Access Compliance Report

Public Rights-of-Way

Intersection ID: 29988	Main Street: REIGATE_RD	Cross Street: BARVAS_ST	Location:	N
ADA ID: 646124201009	Ramp Type: PerpDiag	Initial Pass/Fail: Fail	Overall Compliance: No	Severity Score: 10

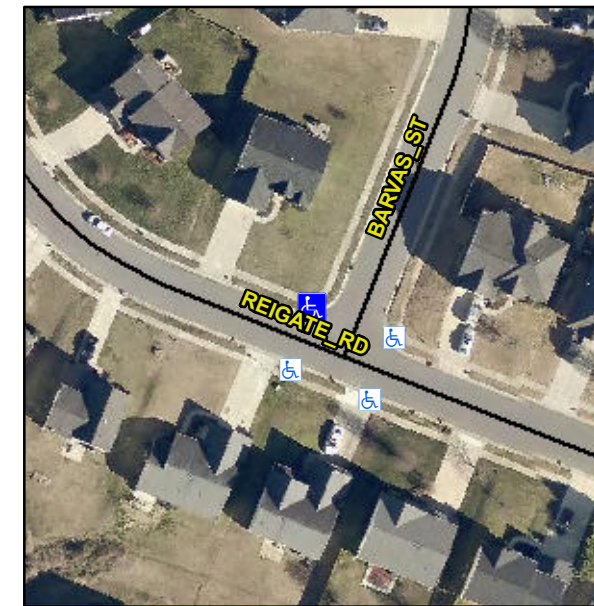
Not Found, R304.5.1, R304.5.3

Compliance	Description	Data	Compliance	Description	Data
N/A	Ramp Length (in)	48.0	Yes	Ramp Slope (%)	7.7
No	Ramp Width (in)	42.0	No	Ramp XSlope (%)	2.8
N/A	Flare Type LT	N/A	N/A	Flare Type RT	N/A
N/A	Flare Slope LT (%)	N/A	N/A	Flare Slope RT (%)	N/A
N/A	Flare Traversable LT?	N/A	N/A	Flare Traversable RT?	N/A
N/A	Landing Length (in)	N/A	N/A	DWS Provided?	N/A
N/A	Landing Width (in)	N/A	N/A	DWS Contrast?	N/A
N/A	Landing Slope (%)	N/A	N/A	DWS Length (in)	N/A
N/A	Landing X Slope (%)	N/A	N/A	DWS Full Width?	N/A
N/A	Landing Curb? (Y/N)	N/A	N/A	DWS Offset (in)	N/A
N/A	Shared Landing?	N/A			
N/A	Gutter Ponding?	N/A	N/A	Gutter Slope (%)	N/A
N/A	Gutter Lip Ht (in)	N/A	N/A	Gutter X Slope (%)	N/A
N/A	Painted X Walk1?	No	N/A	Painted X Walk2?	No
	X Walk 1 Direction	To SW		X Walk 2 Direction	To SE
N/A	X Walk 1 Width (in)	N/A	N/A	X Walk 2 Width (in)	N/A
	X Walk 1 Slope (%)	1.4		X Walk 2 Slope (%)	6.1
	X Walk 1 X Slope (%)	2.7		X Walk 2 X Slope (%)	0.1

Remove & Replace Curb Ramp With Two New Directional Ramps or Equivalent.
